<b>Docket Number:</b>	19-BSTD-01
<b>Project Title:</b>	2019 Alternative Calculation Method Reference Manuals and Compliance Software Tools
<b>TN #:</b>	237680
<b>Document Title:</b>	IES VE T24 v1 Sensitivity Test Model Narrative
<b>Description:</b>	N/A
<b>Filer:</b>	RJ Wichert
<b>Organization:</b>	California Energy Commission
<b>Submitter Role:</b>	Commission Staff
<b>Submission Date:</b>	5/5/2021 6:57:18 PM
<b>Docketed Date:</b>	5/5/2021

## IES Narrative

## Matrix Narrative for Failing Cases

Figure 1: IESVE TES loop and ChWL

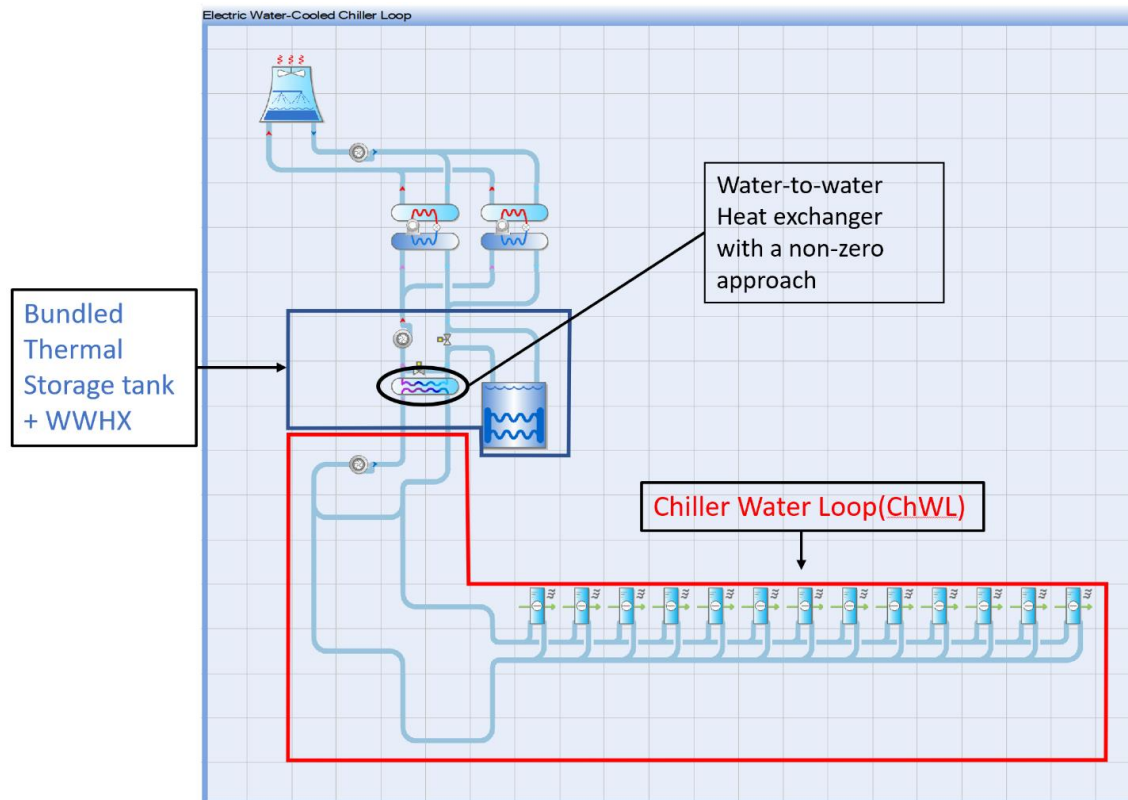
- CEC Comment: Higher TDV Energy in the TES model than the Baserun model.

The TES model in IESVE has a Water-to-water heat exchanger (WWHX) that transfers heat between the TES loop and the ChWL (see Figure 1 below). This heat exchanger is permanently coupled with the TES tank to avoid any potential mixing of water/glycol with water only; thus maintaining the heat transfer properties of water in the Chilled Water Loop. The WWHX has a non-zero approach temperature. i.e., there will always be a temperature drop in the WWHX. To account for this temperature drop, when the chiller is cooling the building, the chiller leaving water temperature needs to be lower than the required ChWL supply temperature (44°F) because it must first overcome the inefficiency of the WWHX.

However, the baseline model (400006) does not have a WWHX. As a result, the chiller water leaving temperature is 44°F.

Since the chillers in the TES model has to cool the water to a lower temperature (to account for the temperature drop in the WWHX) the chillers consume more energy than the baseline chiller. This has therefore been reflected in the TDV of the model. Figures below show the TDV of the baseline chiller

Figure 4: Different Model Methods using in IESVE and CBECC-Com

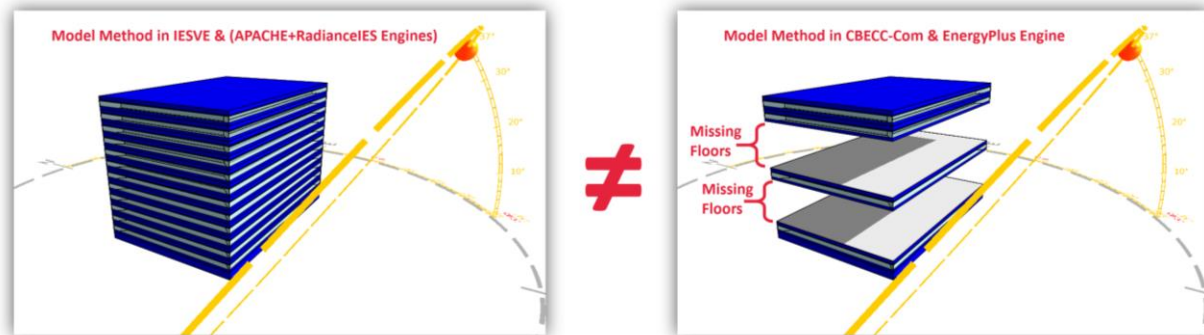
- CEC Comment: Higher TDV Energy in the Daylight Test model than the Baserun model

It is also worth noting that the deviation in lighting energy with these daylighting ECM strategies are for a very deep-plan building. i.e. very low fractional results are anticipated. However, the fractional differences can likely be attributed to oversimplification methods in the CBECC-Com model, which does

not model over 50% of the building. CBECC-Com simplifies the simulation by using floor multipliers, which is inaccurately accounting for the full energy-balance dynamics in over 50% of the building, bypasses requirements of ASHRAE Standard 140, as demonstrated visually in Figure 4.

Figure 9: Psychrometric chart showing the condition of the air presented to the heating coil for LGStore 1 at 7.30 on the 11<sup>th</sup> Feb

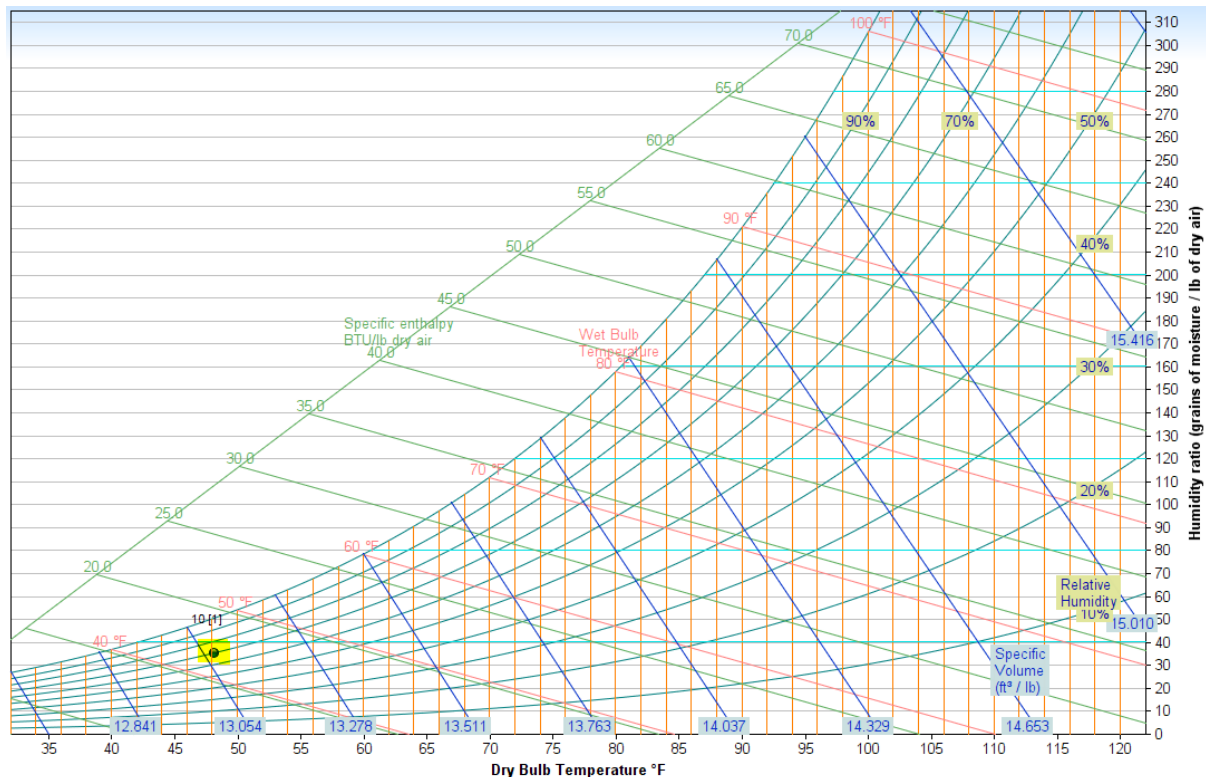
- CEC Comment: The 1013906-RetIStp-EvapCooler TDV Energy is moving in the opposite direction to CBECC

For this model IES is showing a slight increase in TDV (0.98%) versus a negative for CBECC. This is due to a small increase in heating energy (8%) and the relative contribution that heating makes in this model.

This can be explained by some additional heating energy required during the morning heat up. The contribution of the direct evaporative cooling means that temperature presented to the heating coil can be a lower temperature. See below for a psychrometric chart showing the condition of the air presented to a coil (LGStore1) at 7.30 on Feb 11<sup>th</sup>. The resulting conditions means that the dry bulb temperature is 53.11 DegF. In the baseline system this condition at the exact same time is 60.55 DegF.
